DRAINAGE INFORMATION SHEET

CITY ADDRESS: 11411 Central Ave. N.E.

RE: DRAINAGE PLAN FOR 11411 CENTRAL AVENUE
(L-21/D30) RECEIVED JANUARY 20, 1987

TITLE
GRADING AND DRAINAGE PLAN

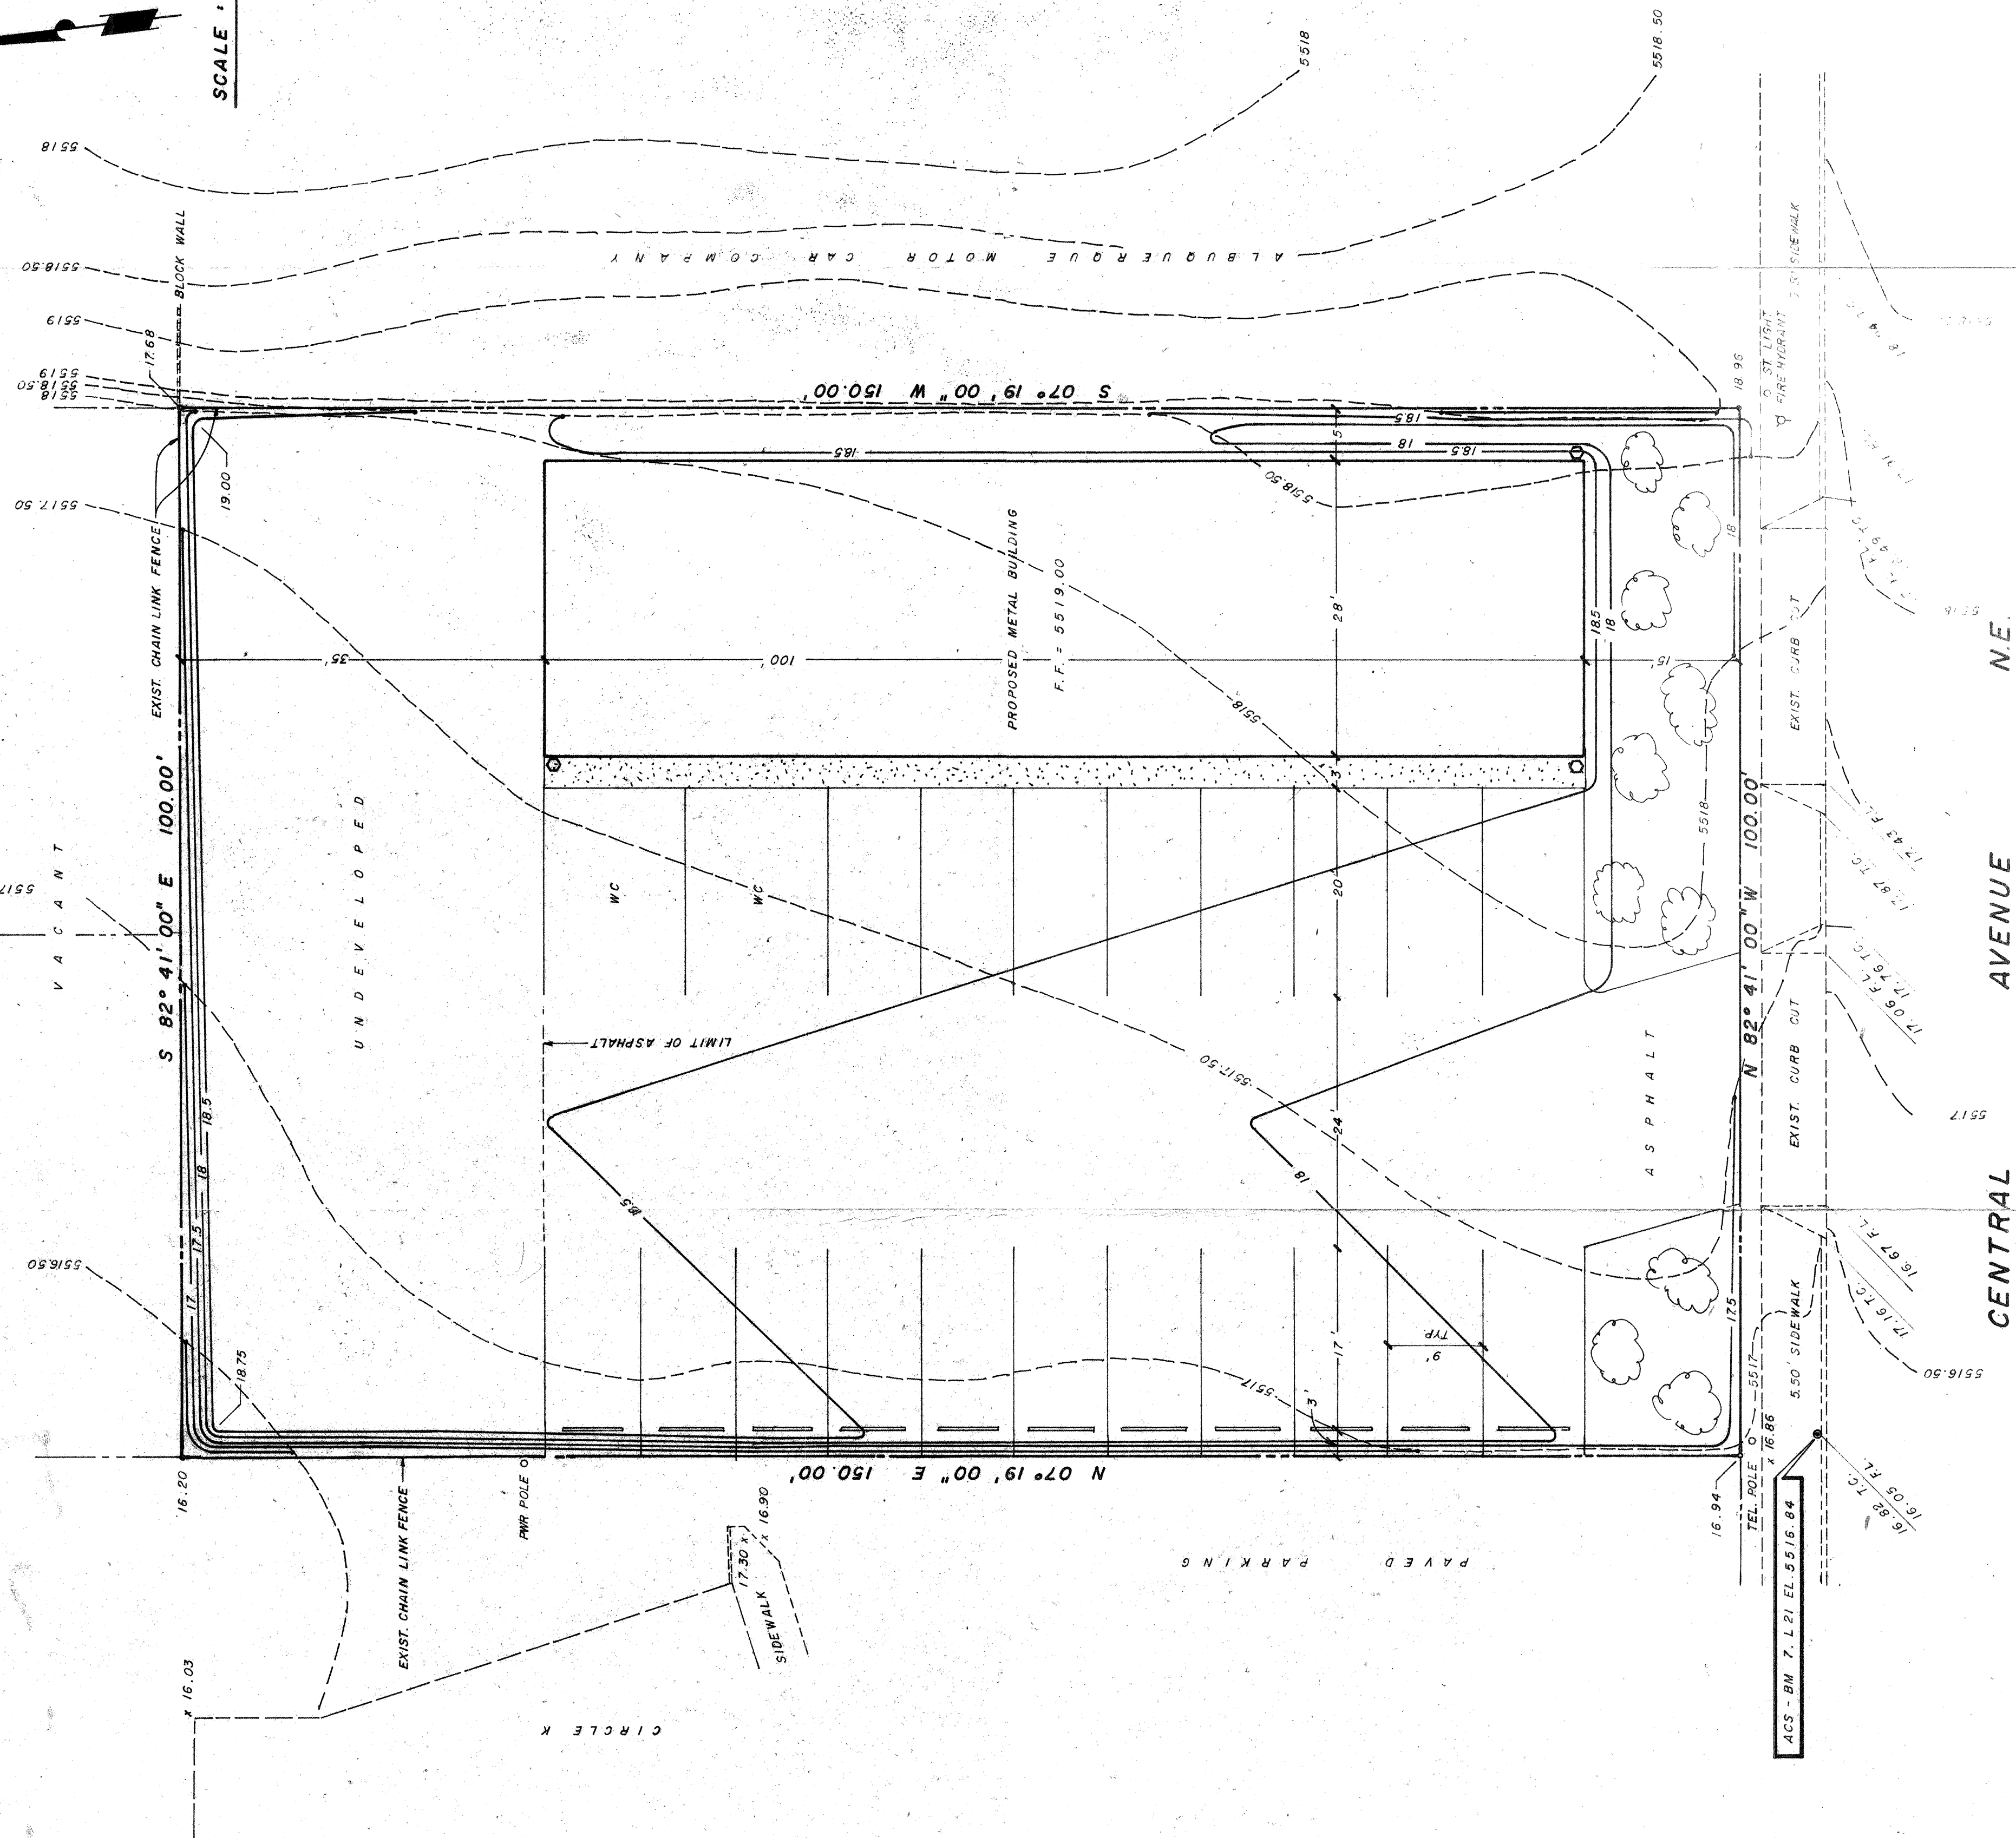
The above referenced plan dated January 19, 1987, is approved for Building Permit. Prior to Certificate of Occupancy release, please submit the recorded plat for the site.

Please attach a copy of this approved plan to both sets of drawings submitted for building permit sign-off.
